**SECTION 009112  
ADDENDUM NUMBER 2**

**PROJECT: UCA CAMPUS DISTRICT LOOP & CHILLER PLANT**

**PROJECT NUMBER: 48879**

UTILITY PLAN - BLDG UTILITIES

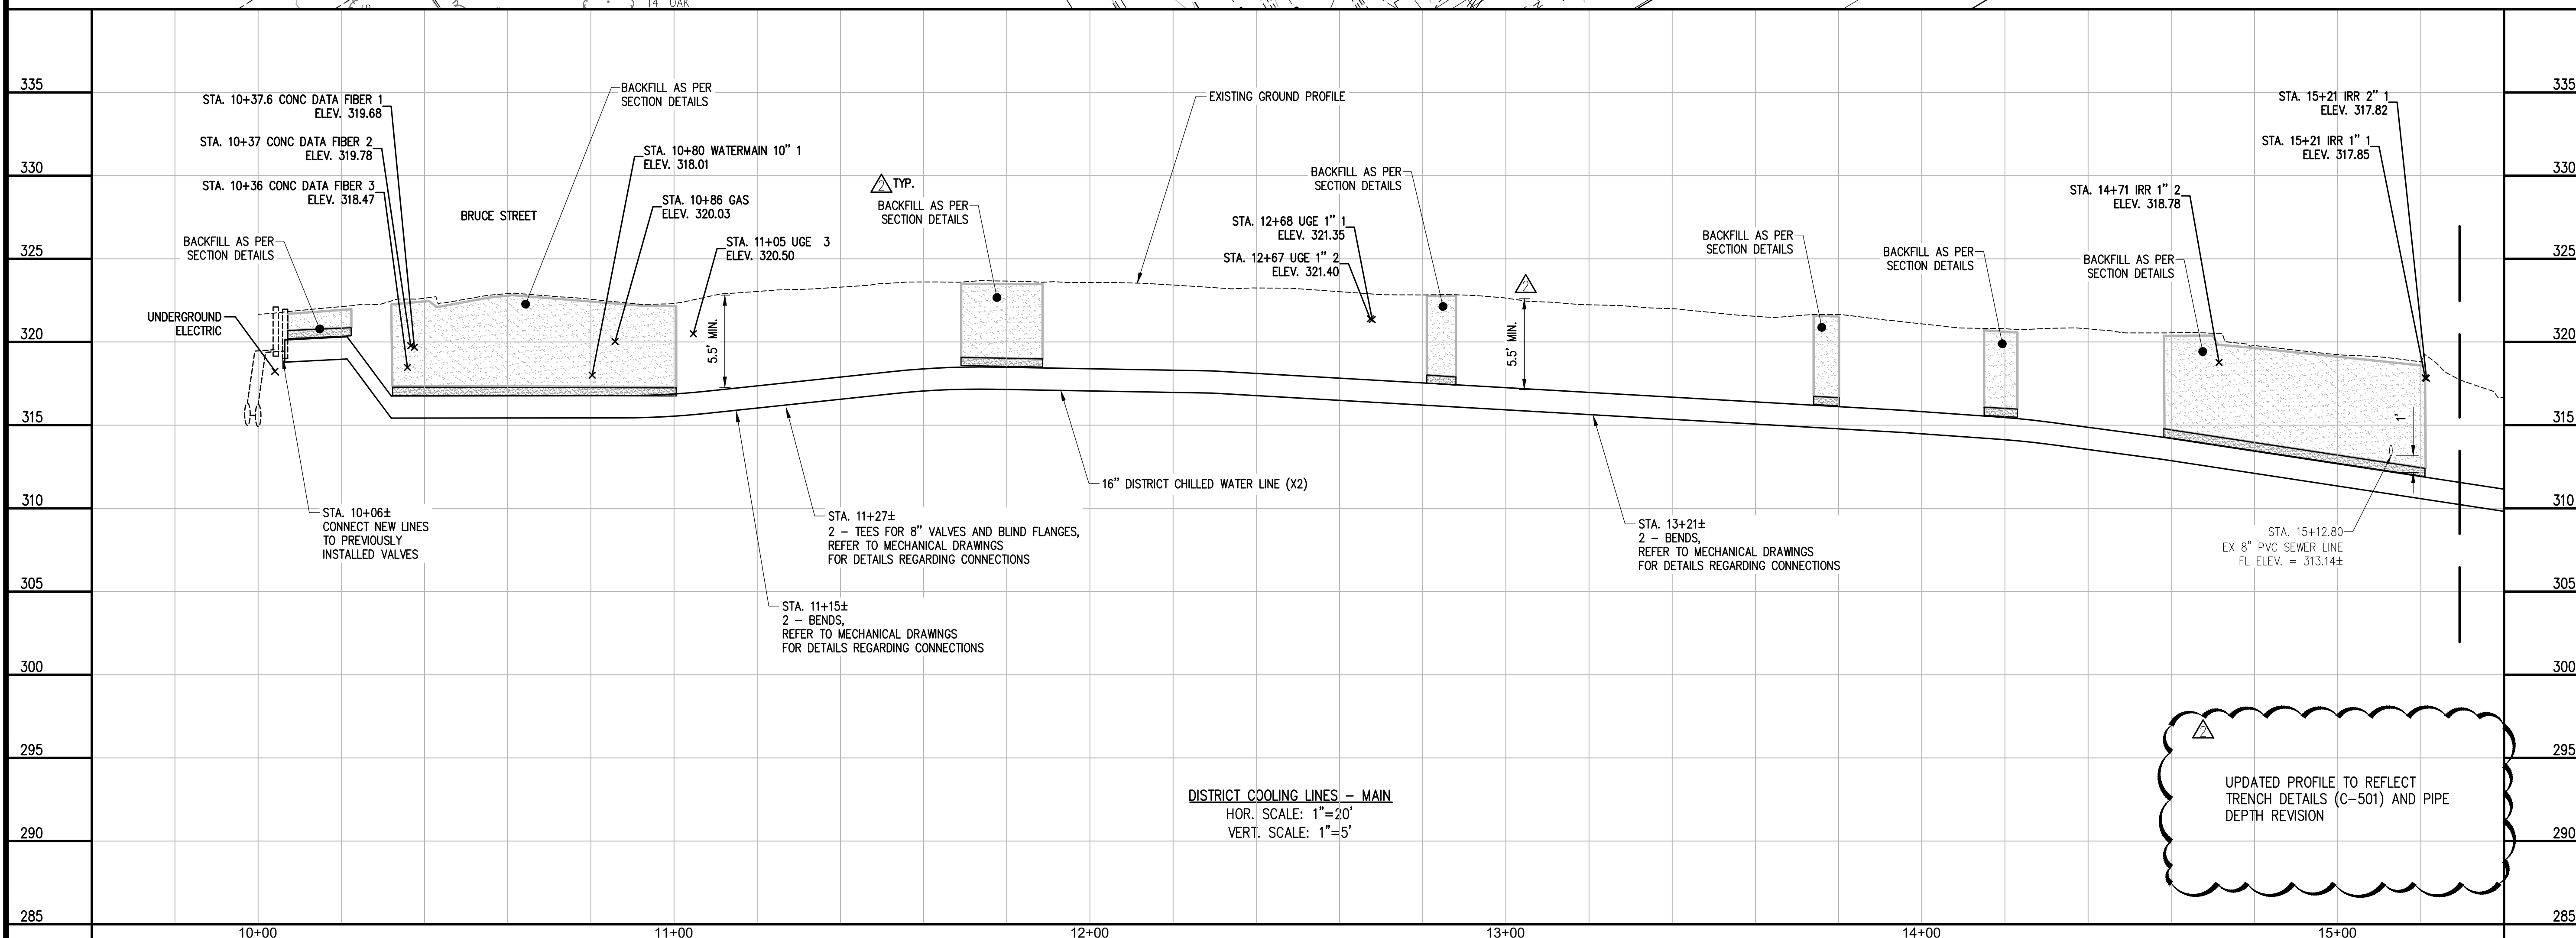
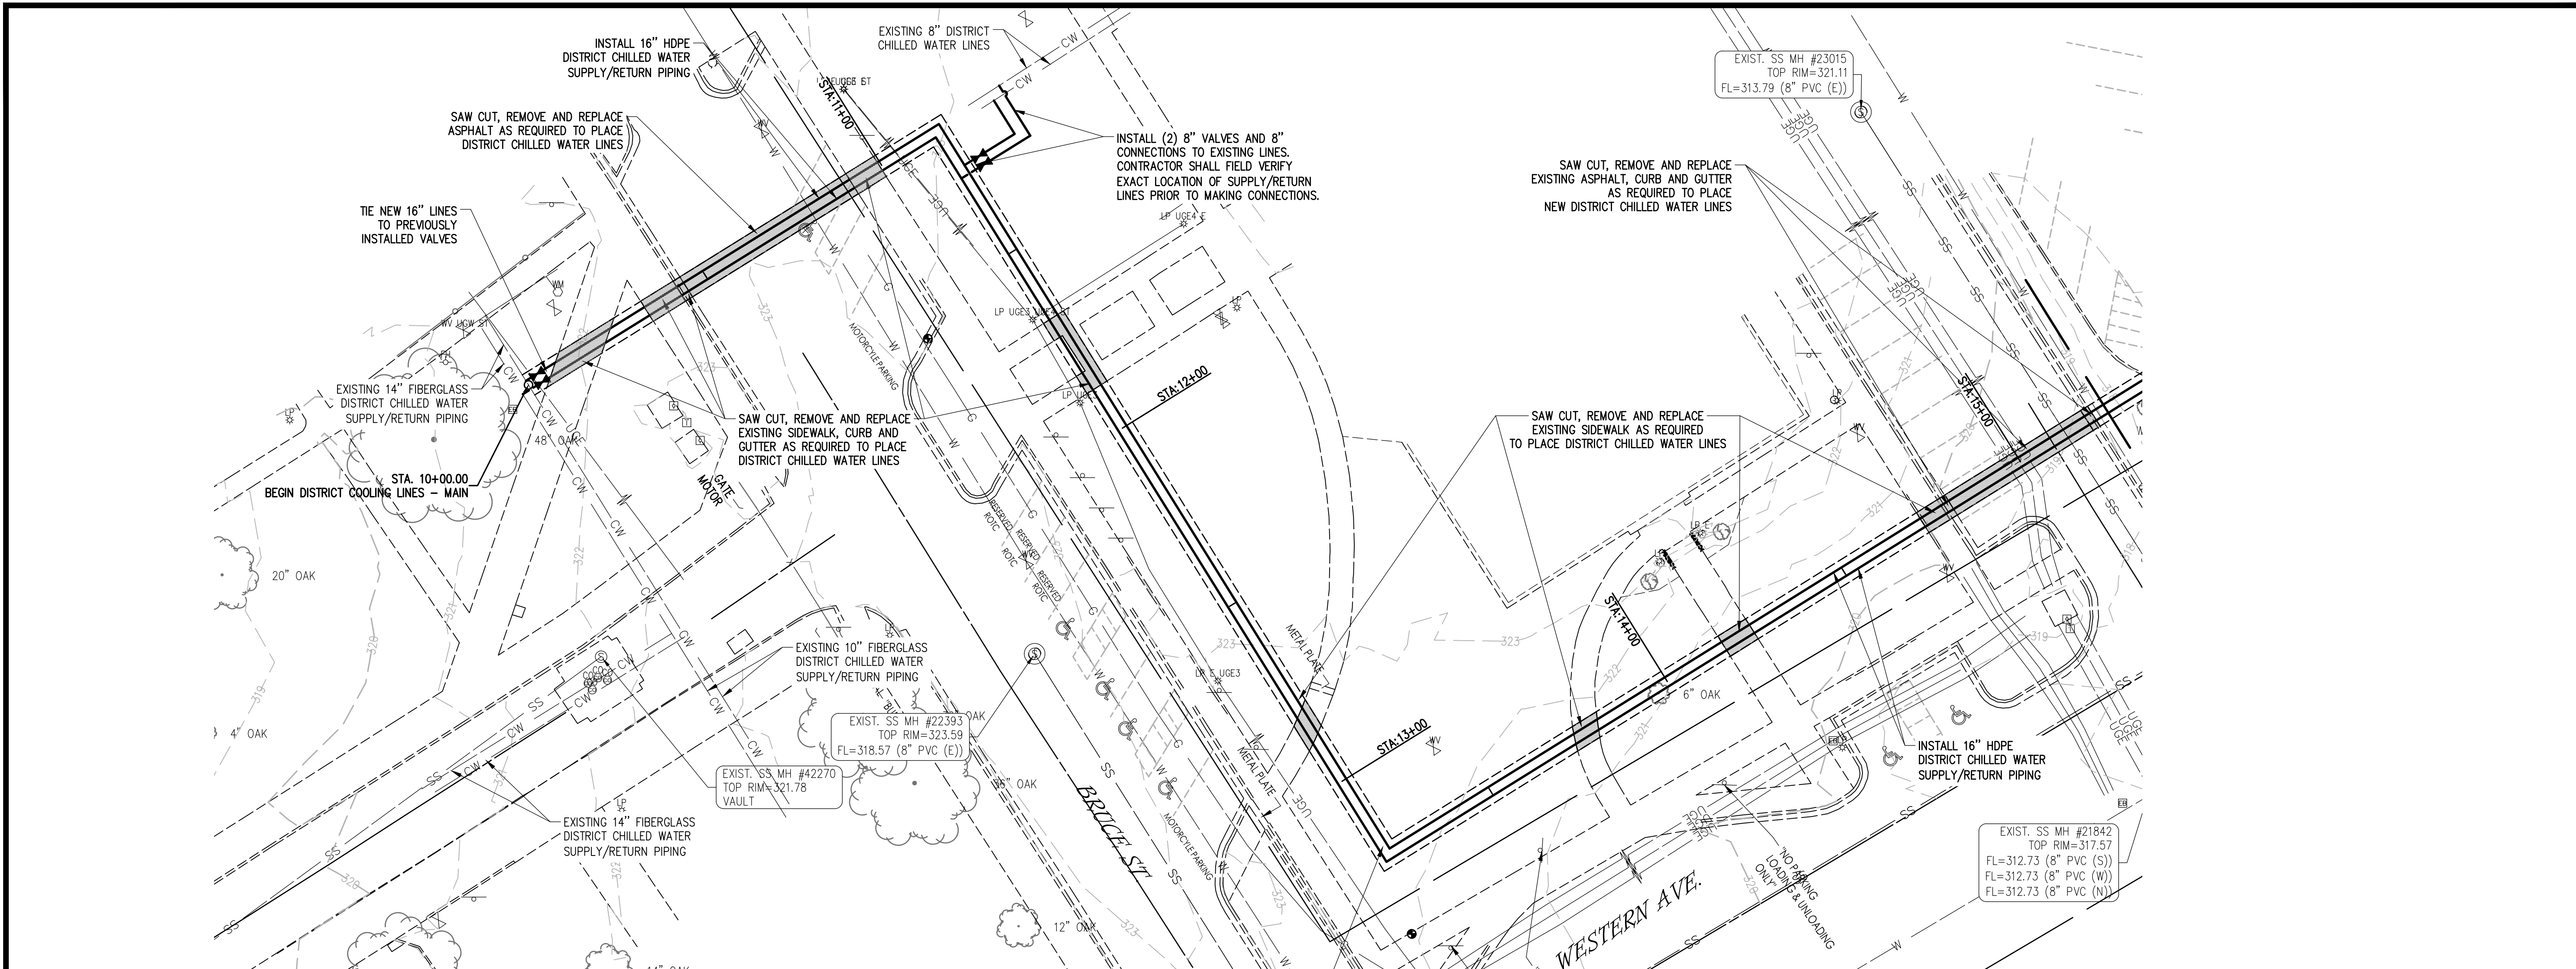
No.	Description	Date
1	Addendum #1	04-21-2026
2	Addendum #2 - Pipe Depth Adjusted Per Trench Detail Revision	04-23-2026

DISTRICT COOLING LINES - MAIN  
P&P

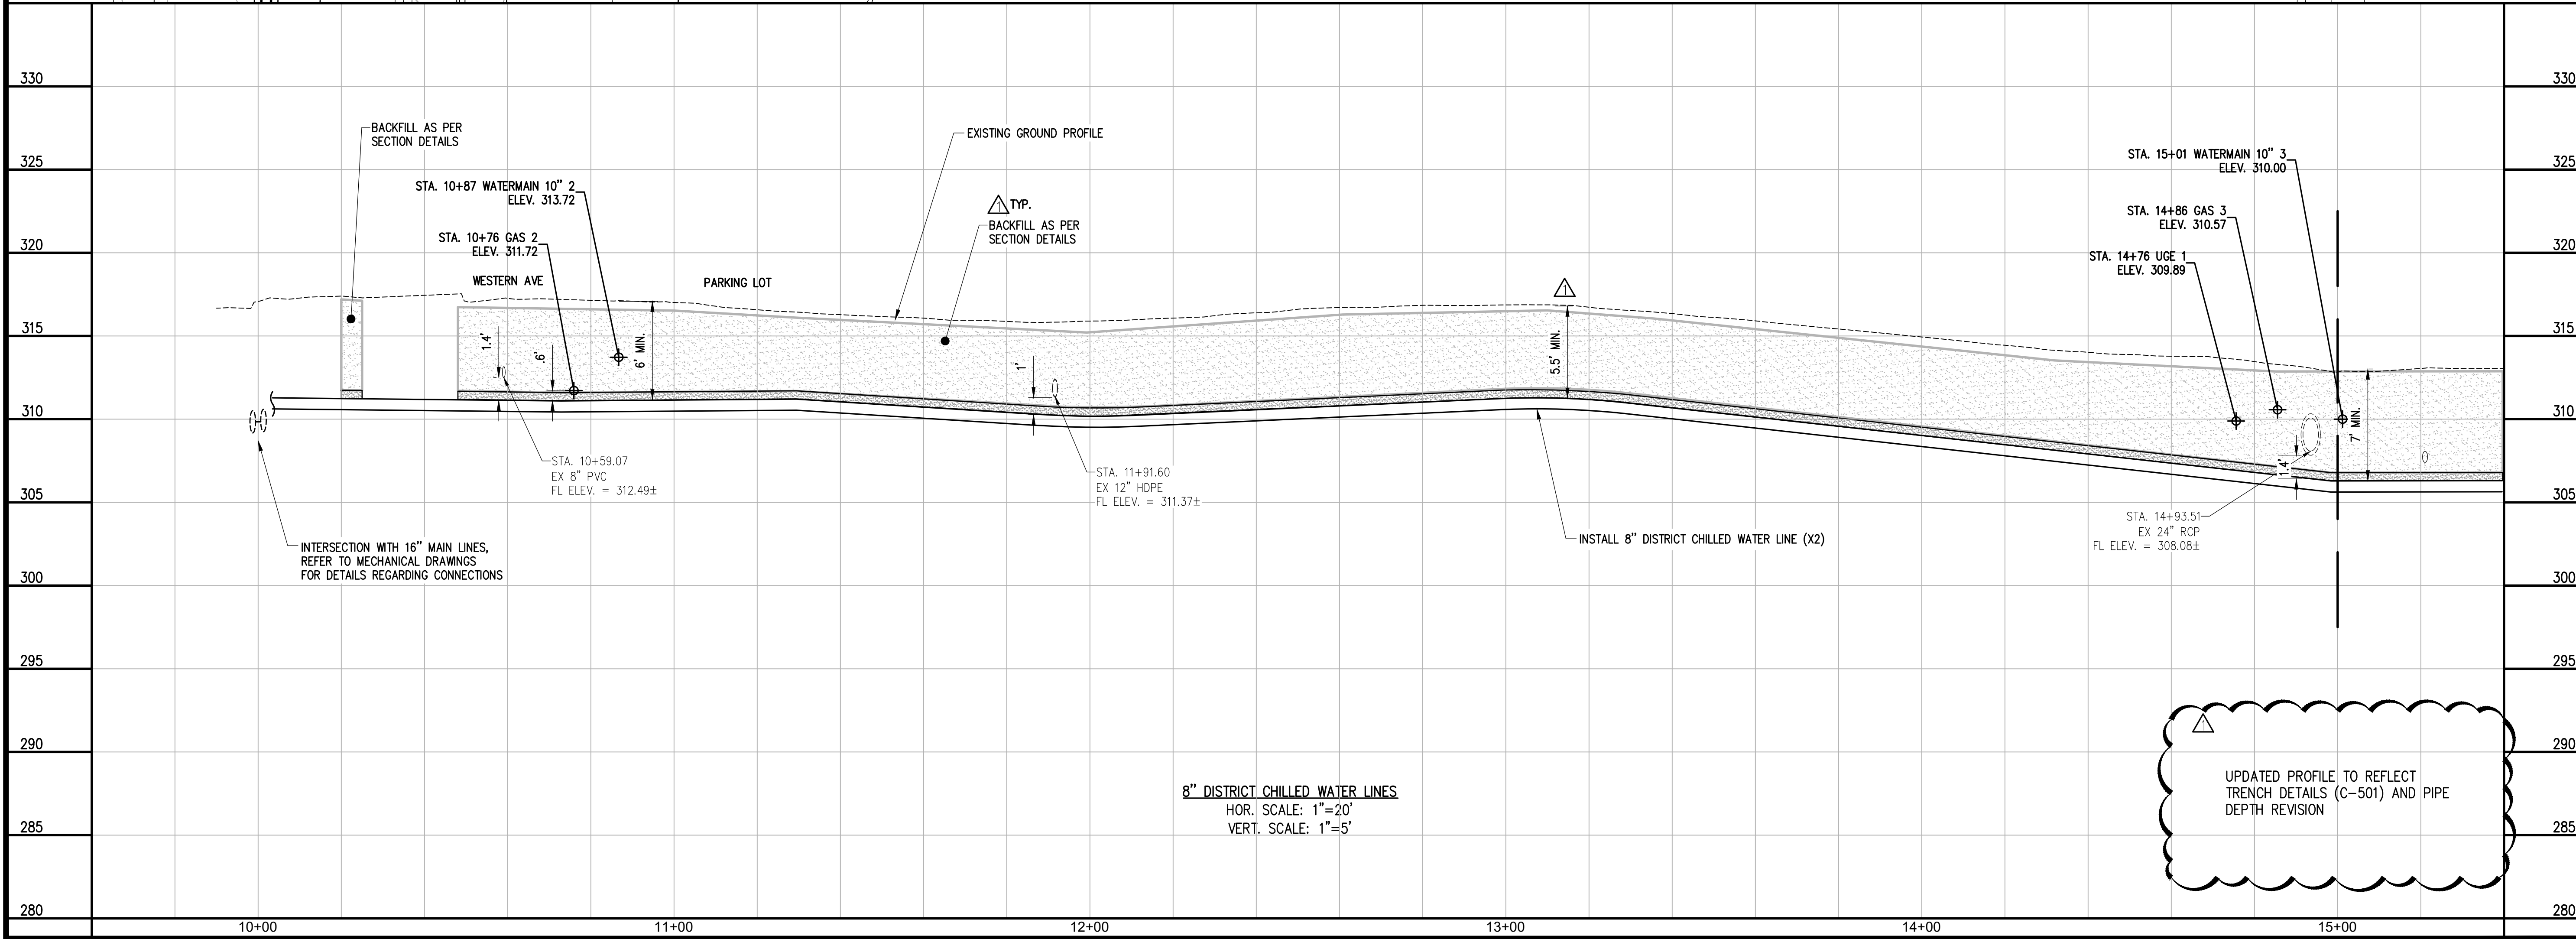
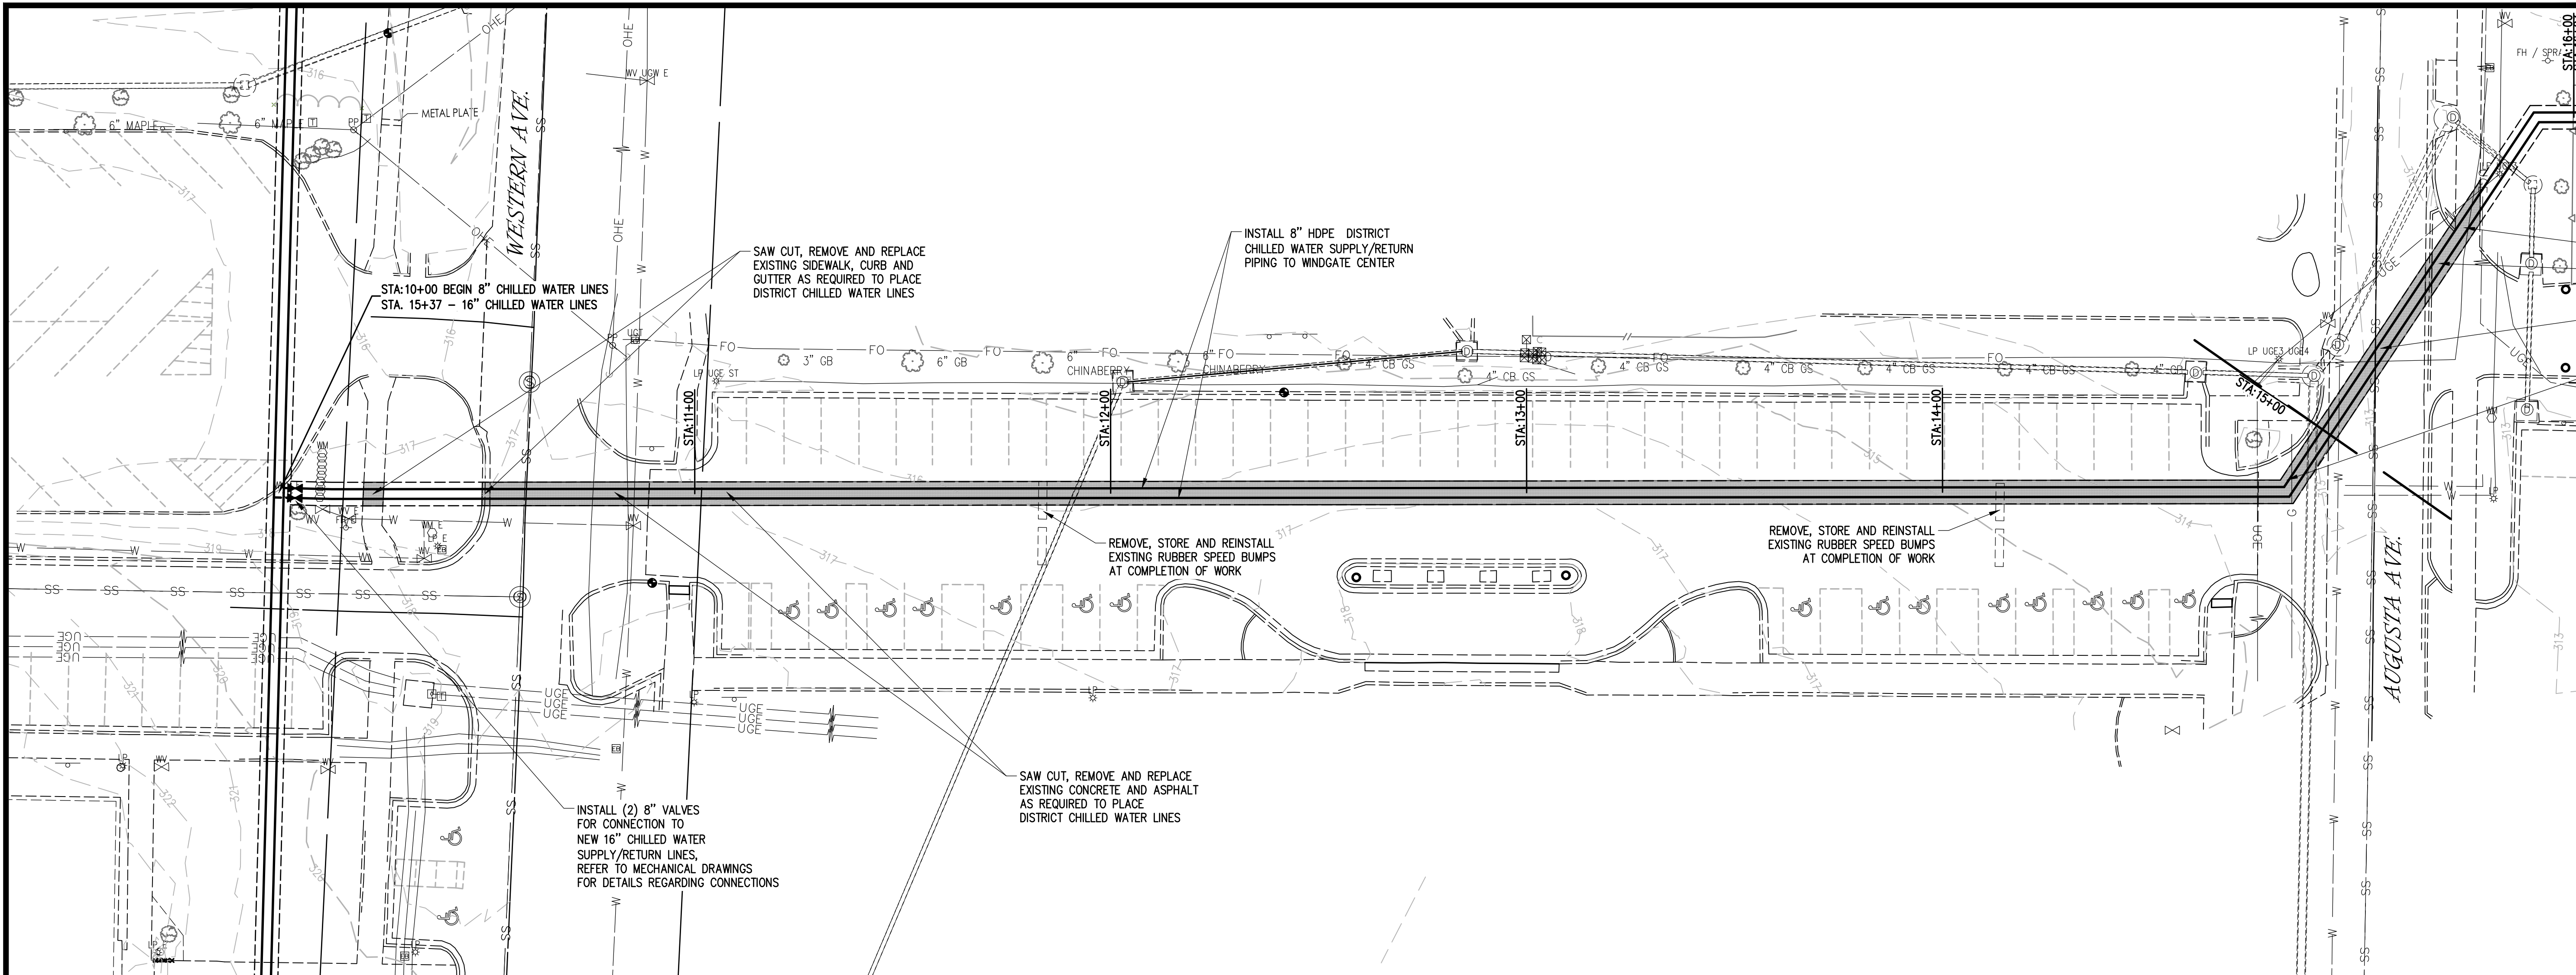
UPDATED PROFILE TO REFLECT TRENCH DETAILS (C-501) AND PIPE DEPTH REVISION

No.	Description	Date
1	Addendum #2 - Pipe Depth Adjusted Per Trench Detail Revision	04-23-2026
